Subject: Transmittal of Revision 1 To Service Bulletin Number

V25000-ENG-72-0330.

ENGINE - DIFFUSER AND COMBUSTION GROUP - PROVIDE NEW BULKHEAD LINER SEGMENTS

V2500-ENG-72-0330

Location of the Combustion Chamber Liner Assembly Bulkhead Segment Figure 1

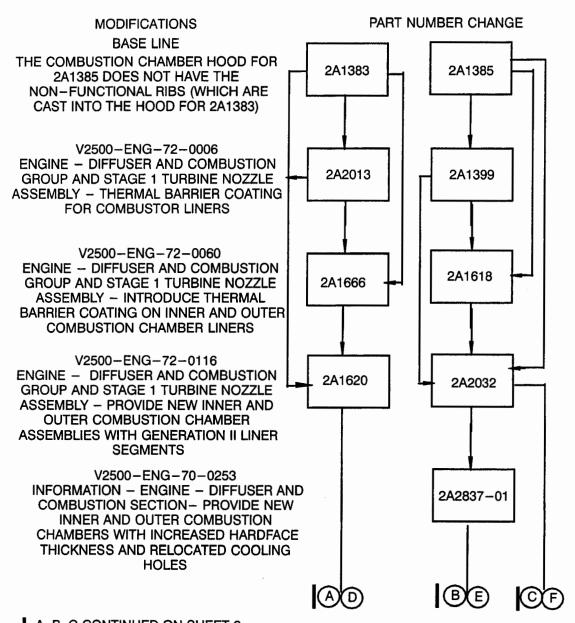
- A. Install the 2A2452 Combustion Chamber Liner Assembly Bulkhead Segment (20 off) by the procedure specified in Reference (3) or (4), Chapter/Section 72-42-61 Repair, VRS3096.
- B. Identify the new Combustion Chamber Case Assembly with the new part number given.
 - (1) Use the procedure specified in Reference (5), Chapter/Section 70-09-00 Marking of Parts.
 - (2) Mark the new part number adjacent to the old part number.

Family Tree - Outer Combustion Chamber Assembly (V2500-Al Only) Ref. Catalog Sequence No. 72-42-61. Fig. 1 Item 501 Revision Figure 2 (Sheet 1 of 2)

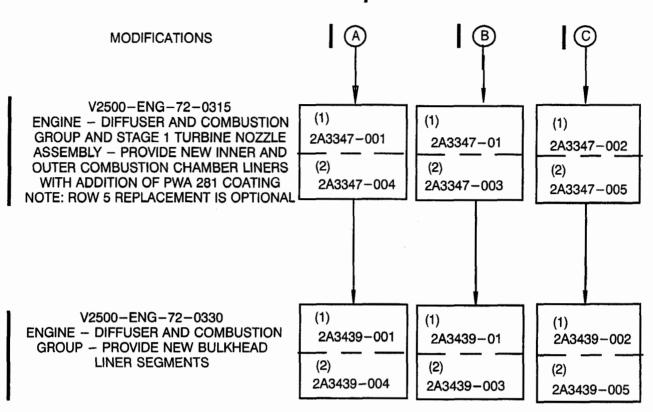
- (1) ROW 5 IS REPLACED
- (2) ROW 5 IS NOT REPLACED

Family Tree - Outer Combustion Chamber Assembly (V2500-Al Only)
Ref. Catalog Sequence No. 72-42-61. Fig. 1 Item 501
Revision Figure 2 (Sheet 2 of 2)

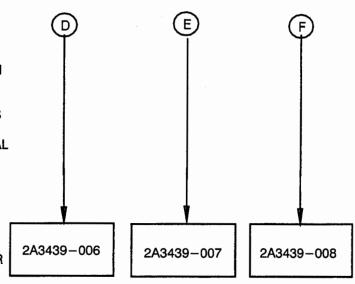
V2500-ENG-72-0315
ENGINE - DIFFUSER AND COMBUSTION
GROUP AND STAGE 1 TURBINE NOZZLE
ASSEMBLY - PROVIDE NEW INNER AND
OUTER COMBUSTION CHAMBER LINERS
WITH ADDITION OF PWA 281 COATING
NOTE: ROW 5 REPLACEMENT IS OPTIONAL

V2500-ENG-72-0330 ENGINE - DIFFUSER AND COMBUSTION GROUP - PROVIDE NEW BULKHEAD LINER SEGMENTS

Family Tree - Outer Combustion Chamber Assembly (All Except V2500-Al)
Ref. Catalog Sequence No. 72-42-61. Fig. 1 Item 501
Figure 3

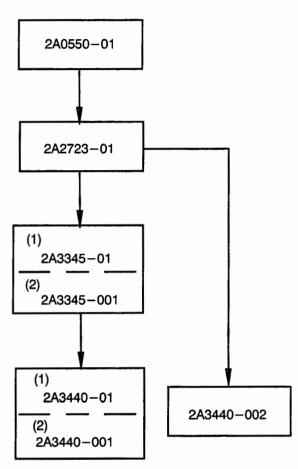
V2500-ENG-72-0315
ENGINE - DIFFUSER AND COMBUSTION
GROUP AND STAGE 1 TURBINE NOZZLE
ASSEMBLY - PROVIDE NEW INNER AND
OUTER COMBUSTION CHAMBER LINERS
WITH ADDITION OF PWA 281 COATING
NOTE: ROW 5 REPLACEMENT IS OPTIONAL

V2500-ENG-72-0330 ENGINE - DIFFUSER AND COMBUSTION GROUP - PROVIDE NEW BULKHEAD LINER SEGMENTS

- (1) ROW 5 IS REPLACED
- (2) ROW 5 IS NOT REPLACED
